SAFETY - RECALL - REPLACEMENT OF THE AFTERTREATMENT REGENERATION
DEVICE EXTENSION PIPE OF CERTAIN C13 TRUCK ENGINES

**PRODUCT IMPROVEMENT PROGRAM FOR REPLACING THE AFTERTREATMENT
REGENERATION DEVICE (ARD) COMBUSTION BODY ON CERTAIN C15 ON-HIGHWAY
TRUCK ENGINES**

Media Number -REBE4750-01

SAFETY - RECALL- REPLACEMENT OF THE AFTERTREATMENT REGENERATION
DEVICE BODY

Image1.1.1

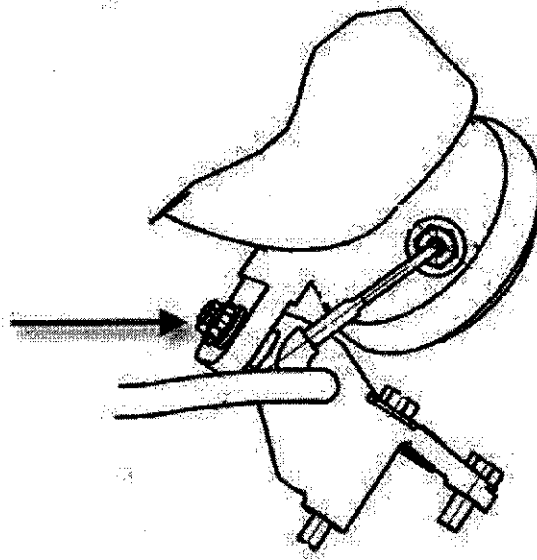
1. Perform an ECM warranty download using Cat ET.
2. Remove combustion head group (ARD). Refer to RENR9706 "Combustion Head Group (ARD) - Removal Procedure".
3. Loosen the OEM band clamp at the bottom of the combustion body and remove the extension pipe attached to the combustion body.
4. Disconnect the temperature sensor located at the bottom of the combustion body. Refer to Image 1.1.1

11. Install the two bolts that attach the combustion body to the support bracket. Refer to Image 1.2.1
12. Apply anti-seize compound to the threads of the temperature sensor located at the bottom of the combustion body and install. Refer to Image 1.1.1

Image1.2.1

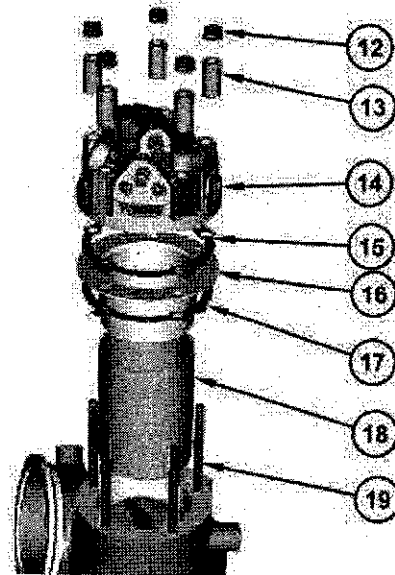
15. Apply anti-seize compound to the threads of studs (19). Install studs (19) with the end that is marked "X" in the Up position. Tighten studs (19) to a torque of 17 +/- 2 N.m (12.5 +/- 1.5 lb ft). Install tube (18). Refer to Image 1.2.1 and Image 1.2.2

Image1.3.1

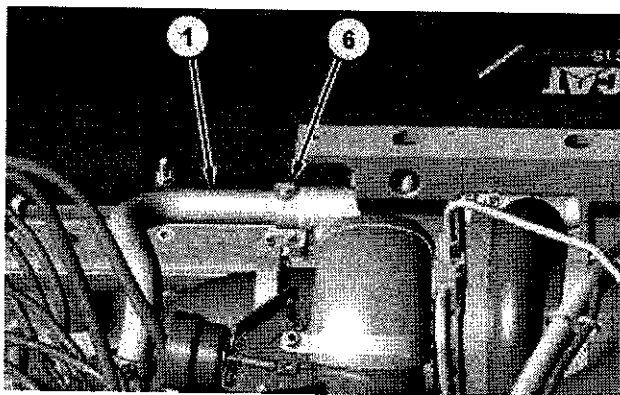
17. Install a new 289-3107 gasket (not pictured) between the 288-6036 tube assembly (1) and ARD Head. Tighten clamp (6). Refer to Image 1.3.1
